Title - Sujet West Saanich NRC UPS Replacement West Saanich NRC UPS Replacement	
Solicitation No. - N° de l'invitation EZ899-221150/B	Amendment No. - N° modif. 003
Client Reference No. - N° de référence du client	Date 2021-11-08
GETS Reference No. - N° de référence de SEAG PW-\$PWY-047-9067	
File No. - N° de dossier PWY-1-44107 (047)	CCC No./N° CCC - FMS No./N° VME
Solicitation Closes - L'invitation prend fin at - à 02:00 PM Pacific Standard Time PST on - le 2021-11-16 Heure Normale du Pacifique HNP	
F.O.B. - F.A.B. Plant-Usine: <input type="checkbox"/> Destination: <input checked="" type="checkbox"/> Other-Autre: <input type="checkbox"/>	
Address Enquiries to: - Adresser toutes questions à: Kyle (PWY), Davis	Buyer Id - Id de l'acheteur pwy047
Telephone No. - N° de téléphone (250) 869-6395 ()	FAX No. - N° de FAX () -
Destination - of Goods, Services, and Construction: Destination - des biens, services et construction: SSC – Dominion Observatory – Victoria, BC

Solicitation Amendment 003 is raised to indicate that:

1. Answer bidder questions in Addendum 3.

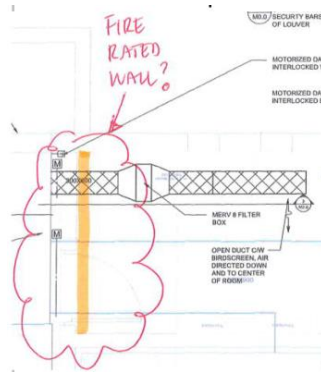
- Q.5** Refer to mechanical drawing M1.0 - Please confirm if the wall in the included scanned sketch is fire rated or not. No fire damper shown but would like to confirm:

- R.5** Consider this wall to be fire rated. Provide fire dampers in bid.
